Land North-East of Junction 10 M42, Dordon

Response to Review of Additional Information prepared
by LUC on behalf of North Warwickshire Borough Council

Hodgetts Estates

20 March 2024

Indicative Masterplan included within the D&A which accompanied the Outline Application

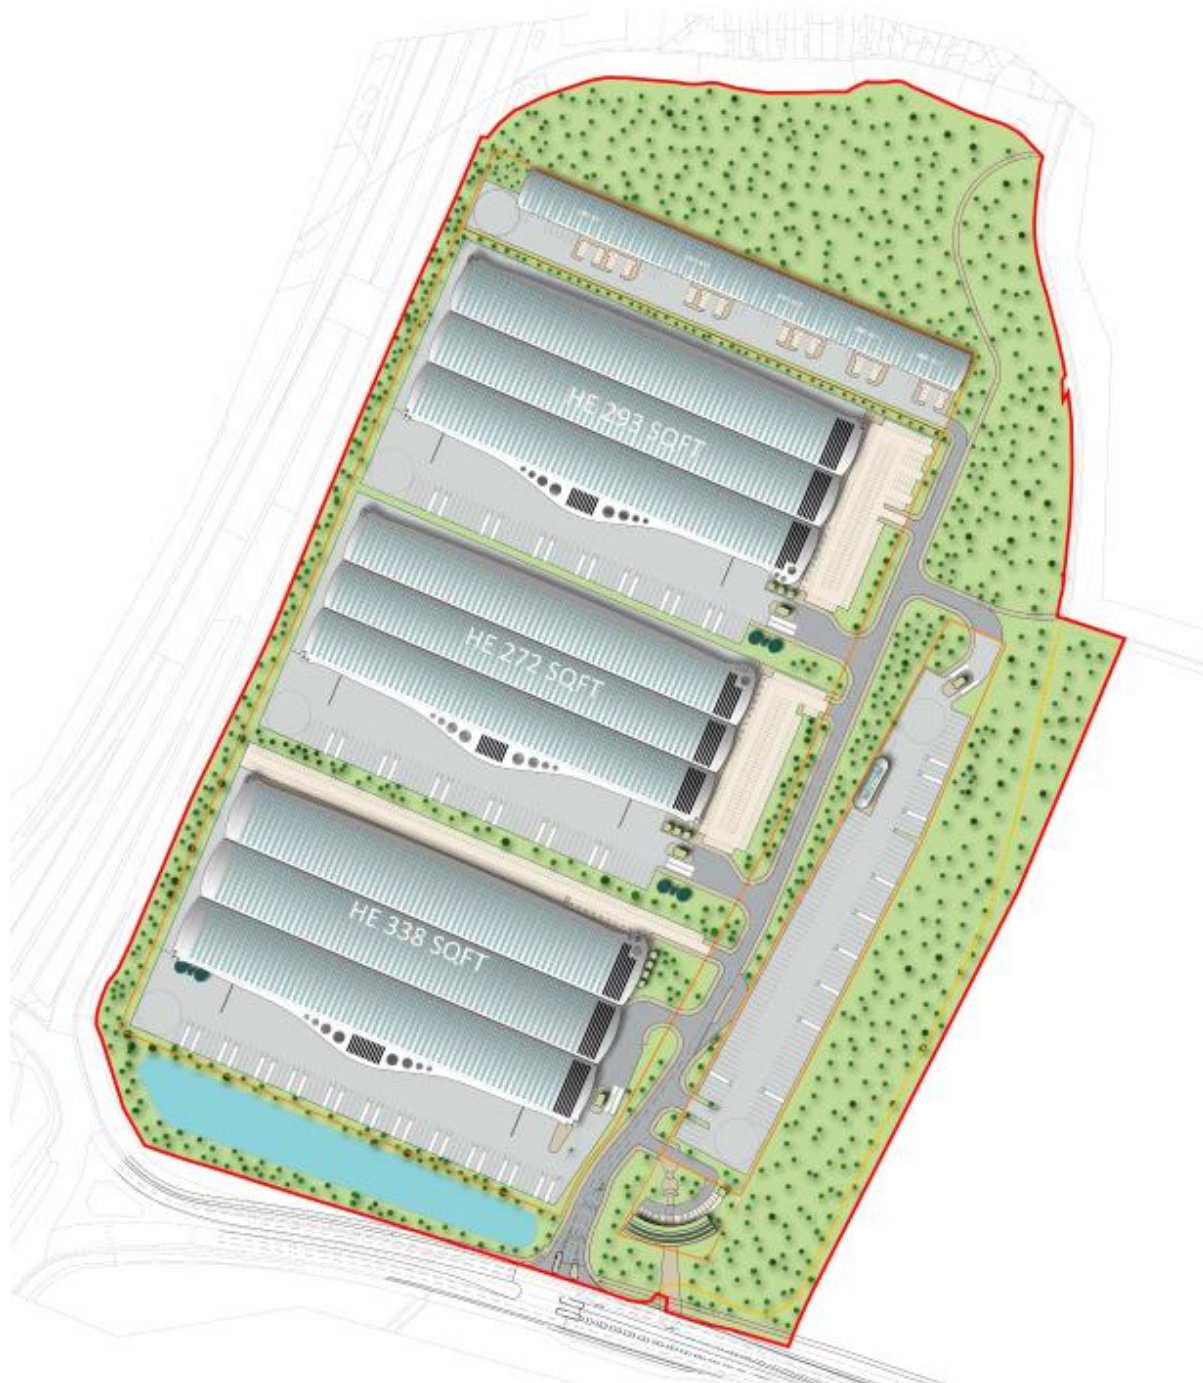
The LUC 4th response notes the inclusion of the alternative indicative masterplan which has been used for the Type 3 photomontages which is considered useful. Both versions of the indicative masterplan are included below.

An alternative indicative masterplan was prepared and used to prepare the Type 3 photomontages. .
